ALERT SERVICE BULLETIN

EQUIPMENT AND FURNISHINGS - Emergency floatation system Inspection of the floatation balloon supply hoses

Revision No.	Date of issue
Revision 0	2020-01-07
Revision 1	2020-02-12

Figure 1

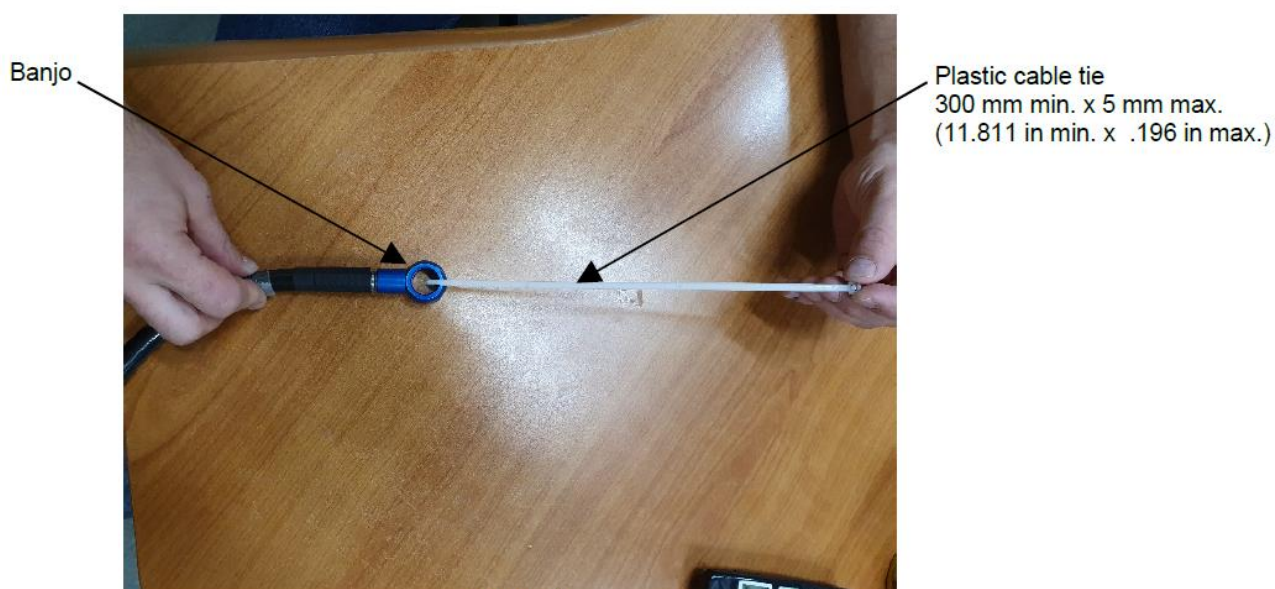
- (1) Inspection of single section hoses (in-service equipment, spare component and Part 21 material)
 - (a) Insert the end of plastic cable tie in the hole of outlet fitting (or banjo) (refer to Figure 1):
 - If the cable tie goes through the fitting (or banjo) freely up to a minimal length of 300 mm (11.811 in), the hose is fully operative (refer to Figure 2),
 - If a blockage occurs in the duct of the fitting (or banjo), the hose is blocked internally and must be replaced:
 - *If your material is Part 145 (in-service equipment and spare component) related:*
Please contact Safran Aerosystems Services to get a replacement part.

- (a) For each section of the hose to be inspected, insert the end of plastic cable tie in the hole(s) of related fitting (or banjo) (refer to Figure 1):
- If the cable tie goes through the fitting (or banjo) freely up to a minimal length of 300 mm (11.811 in), the hose is fully operative (refer to Figure 2),
 - If a blockage occurs in the duct of fitting (or banjo), the hose is blocked internally and must be replaced:
 - *If your material is Part 145 (in-service equipment and spare component) related:*
Please contact Safran Aerosystems Services to get a replacement part.
